Sheet 10 today, and what goes wrong

Erbil plant - InteliNeo 5500 master - PLC sheet 10 "PV req step protection"

What I want to change

Erbil plant - InteliNeo 5500 master - PLC sheet 10 "PV req step protection"

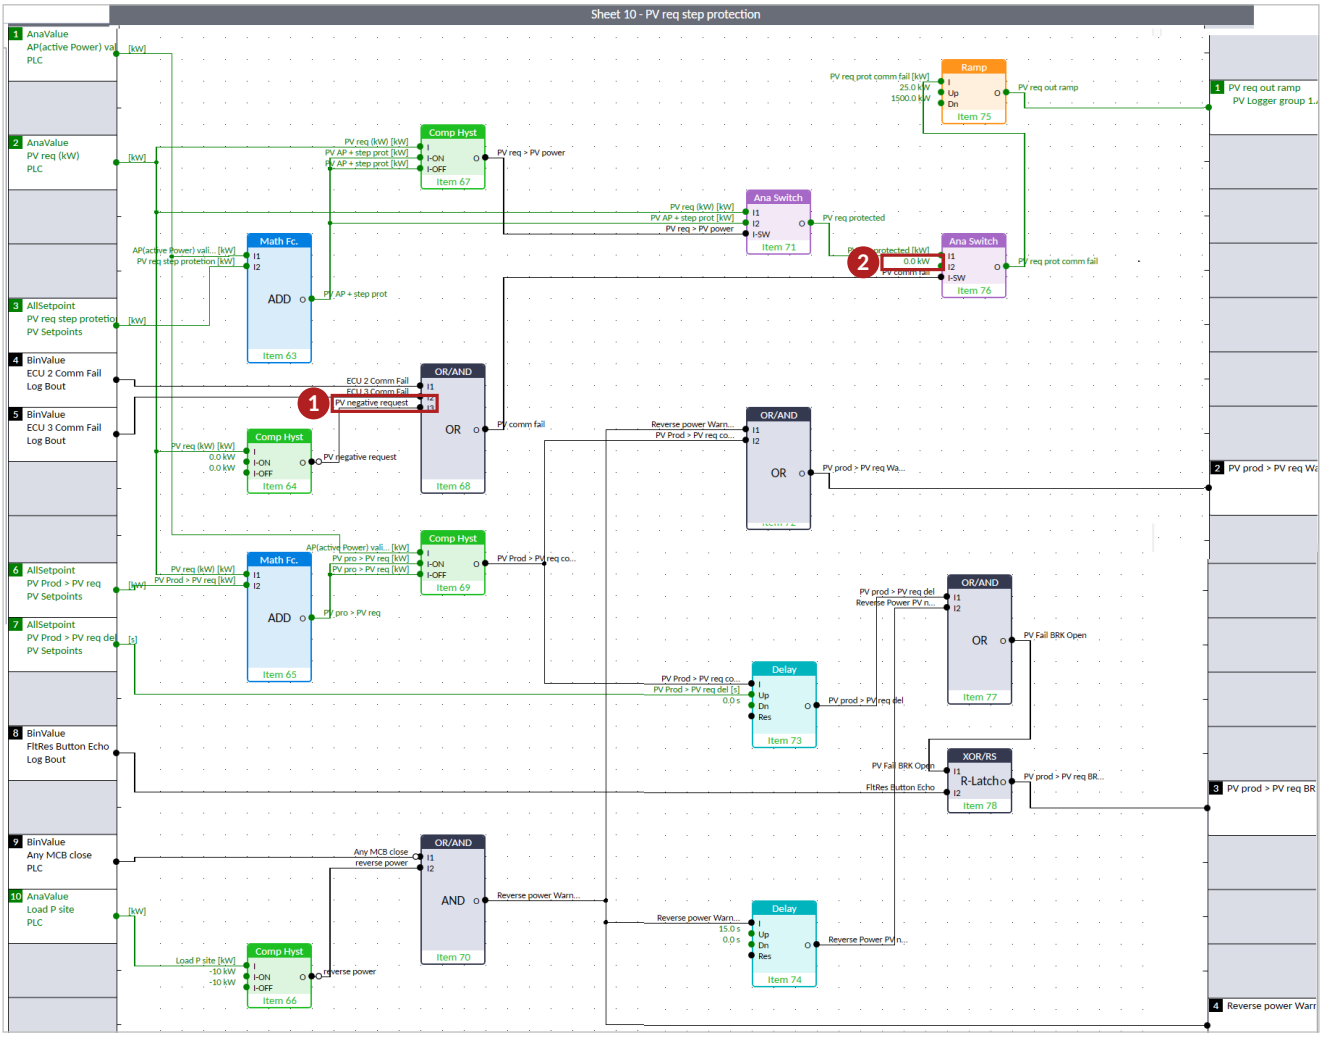
Three small edits, nothing else. The switch (now Item 77) gets its own output on its second input (2). So when a reply is missed, it just keeps sending the last setpoint. Nothing drops, nobody notices. Item 68 (1) now only listens to the two real comm fail signals, so if the controller really wants zero, zero still goes out. And one new timer, Item 65 (3), raises a flag called PV comm lost if the logger stays silent for five minutes. For now that flag only goes to an alarm.

With a healthy link, the program does exactly what it does today. I ran the whole program block by block against our own history to check that. While the link is down, nothing is different from today either: the inverters keep their last setpoint in both versions, the gensets have 25 % in hand, the controller's own protections still work without the logger, and after five minutes we get the flag. If anyone wants it back, we load the archive from 14 October. One minute.

On the day of 14 October this change would have taken away three of the eleven UPS sheddings and given us about 350 kWh more solar. And it is the first step before we can run fewer gensets, which is where the real fuel saving is.

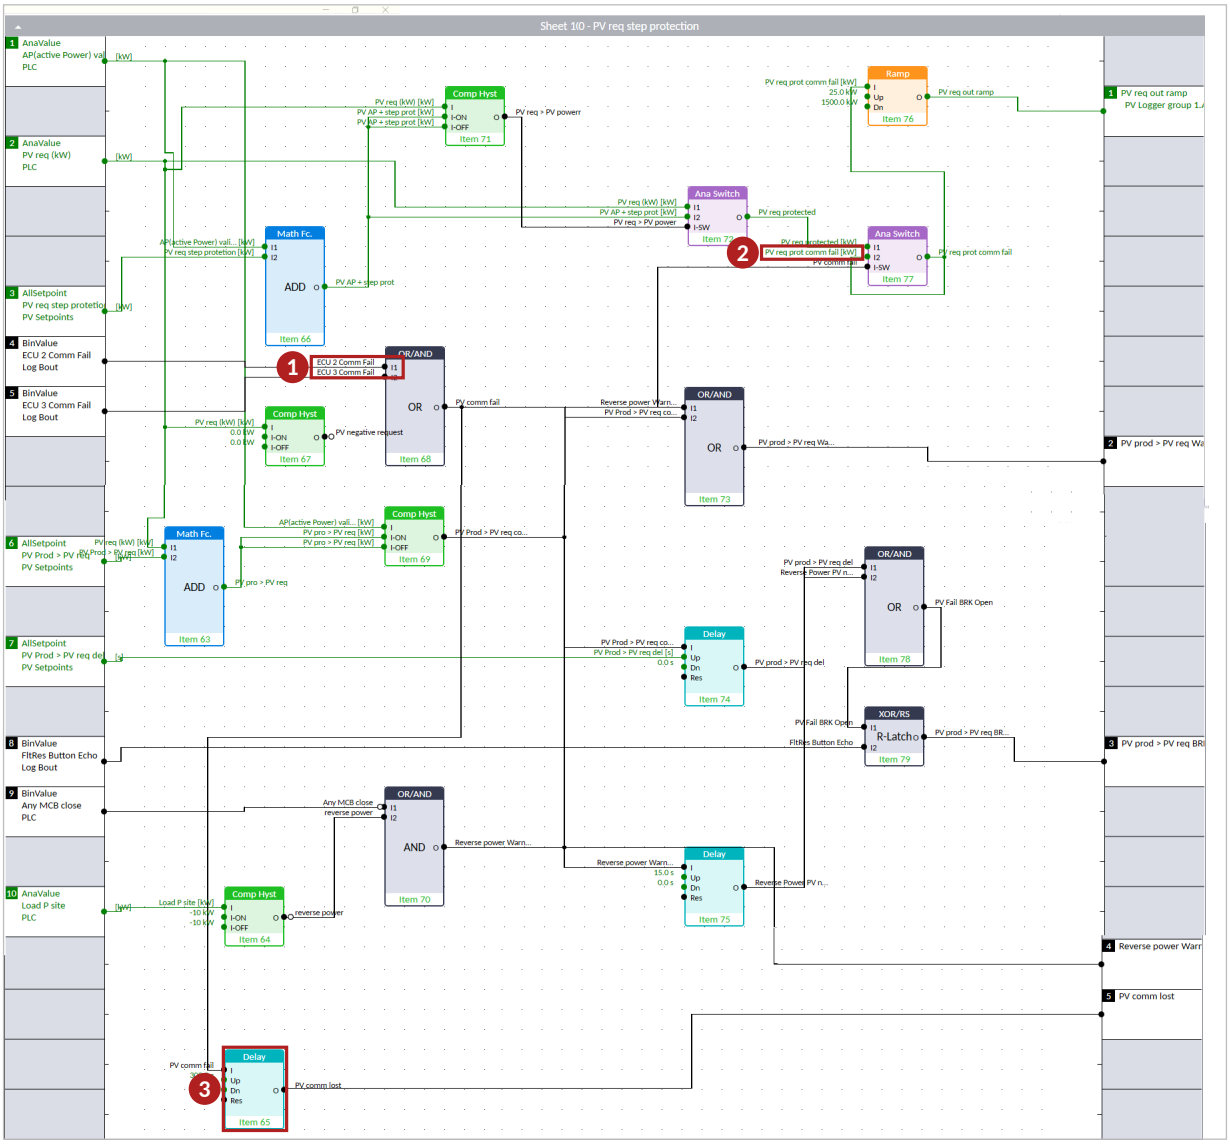
This sheet sends the solar plant its setpoint. Most of it is fine. The problem is one small switch, Item 76. Normally it just passes the request through. But if the controller misses even one reply from the PV logger, Item 68 (1) flips the switch, and the other side of the switch is a fixed 0.0 kW (2). So the solar plant gets told: zero.

The inverters do what they are told, within seconds. The gensets were running at 25 % and now they carry everything. The UPS logic sees that jump and sheds the UPS. Then the reply comes back, and the solar has to climb up again, 100 kW at a time, about five minutes. This happens five to thirty times a day.

And here is the silly part: while the link is down, the zero never even reaches the logger. It arrives when the link is back, so it protects nothing. We just lose production every time.
